Subject: Calvert Cliffs Nuclear Power Plant
Unit Nos. 1 & 2, Docket Nos. 50-317 & 50-318
NUREG-0737, Item II.B.1
Reactor Coolant System Vents

RESPONSE TO REQUEST FOR ADDITIONAL INFORMATION ON THE REACTOR
COOLANT VENT SYSTEM (NUREG-0737 ITEM II.B.1)

REACTOR COOLANT VENT SYSTEM
FIG. 1

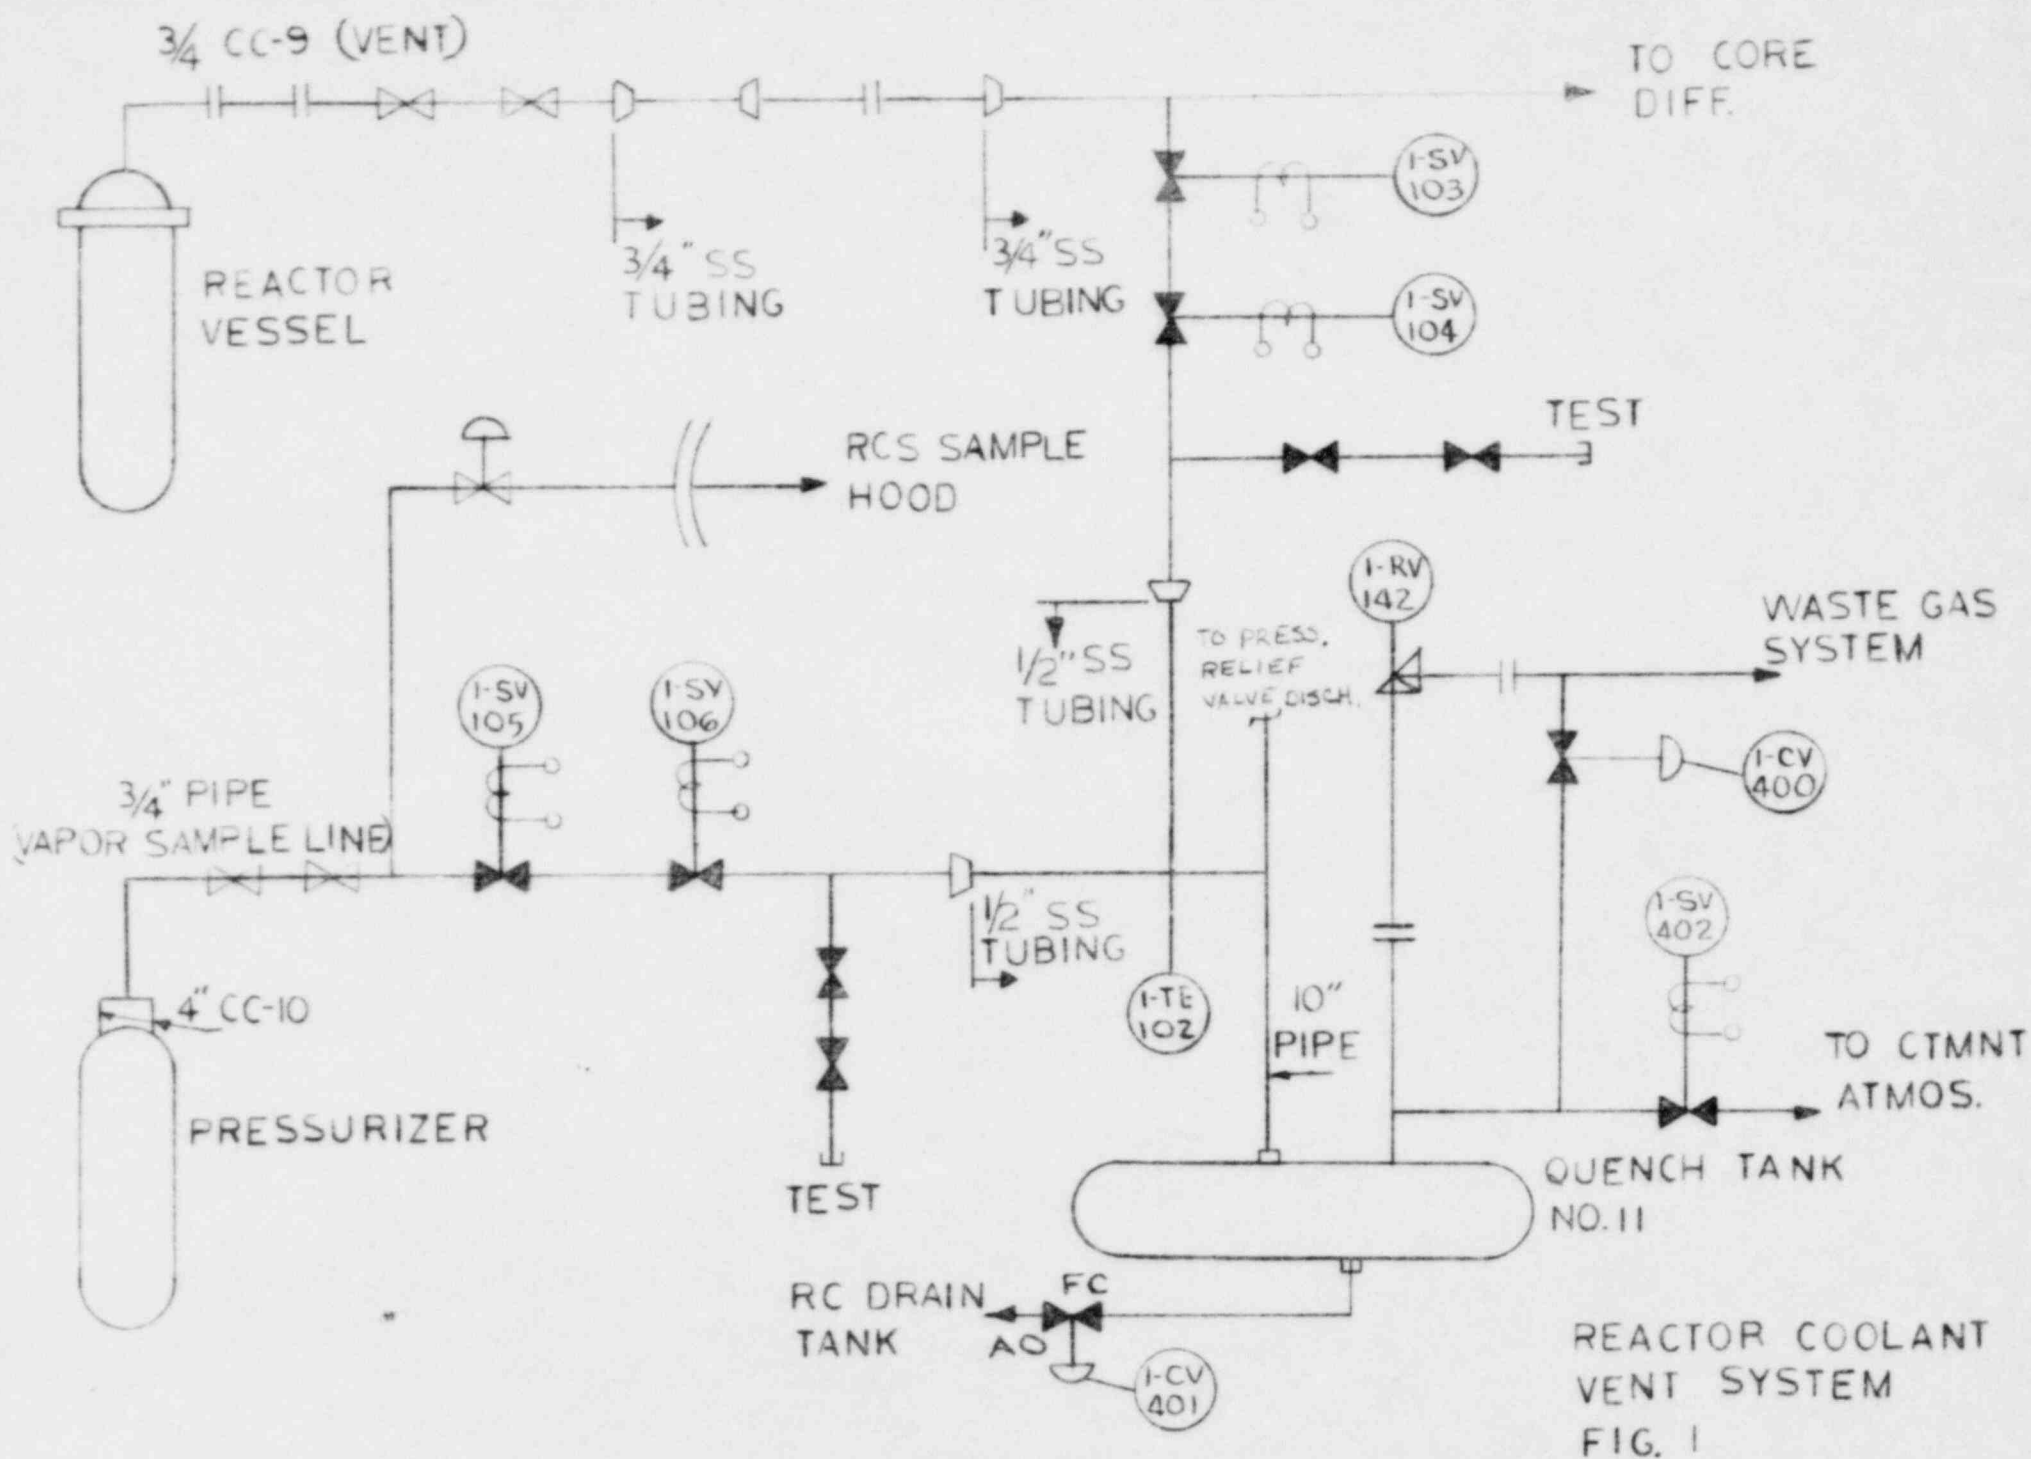
Valves 1-SV-101, 1-SV-102, 1-SV-103, and 1-SV-104 shown in the original venting system diagram are actually designated for Calvert Cliffs Unit 1(2) as 1(2)-SV-103, 1(2)-SV-104, 1(2)-SV-105, and 1(2)-SV-106, respectively. The piping and valves were installed to the following criteria:

- (i) valves 1(2)-SV-103, 1(2)-SV-104, 1(2)-SV-105, and 1(2)-SV-106 are ASME Section III, 1974 Class I; while
- (ii) all piping is per ASME Section III, 1974 Class II.

A revised figure is attached.
